Chesapeake modifications to Regional Standards Third Edition

HRPDC Regional Construction Standards

Amendment No. 1

This Amendment modifies, revises, and /or updates the Third Edition dated January 2003.

TRENCH WIDTH DETAIL FOR PAYMENT OF CONTINGENT ITEMS
NOT TO SCALE

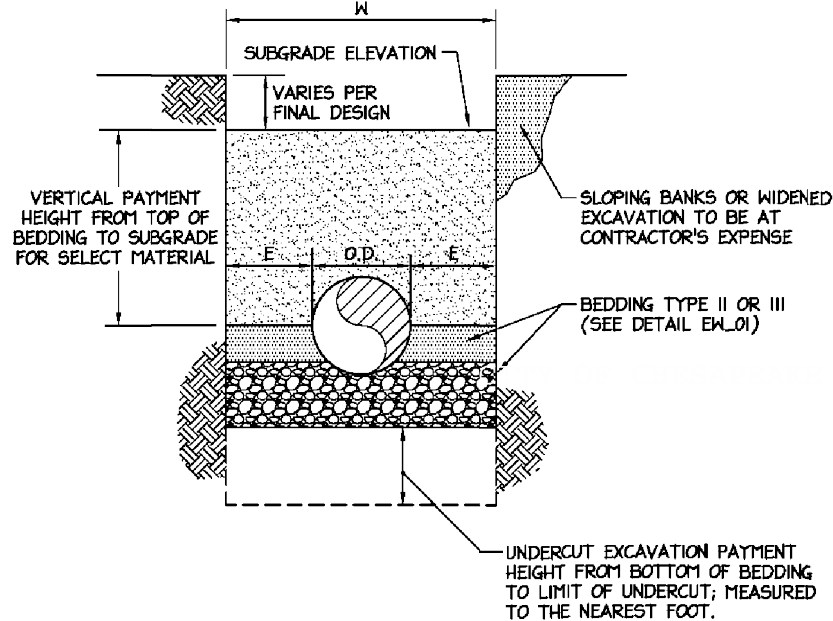
1. Change Depth (FT)-Dimension (W) Table as follows ,and change the second note below the table to read " ...GREATER of the two dimensions listed, or O.D. + 2E " instead of "...LESSER of the two dimensions listed":

Depth (FT.)	Dimension "W"*
0 - 4	2.5' OR O.D. + 2E
4 - 10	3.0' OR O.D. + 2E
10 - 14	4.0' OR O.D. + 2E
14 - 20	5.0' OR O.D. + 2E
OVER 20	Special DESIGN - SEE CONTRACT DOCUMENTS
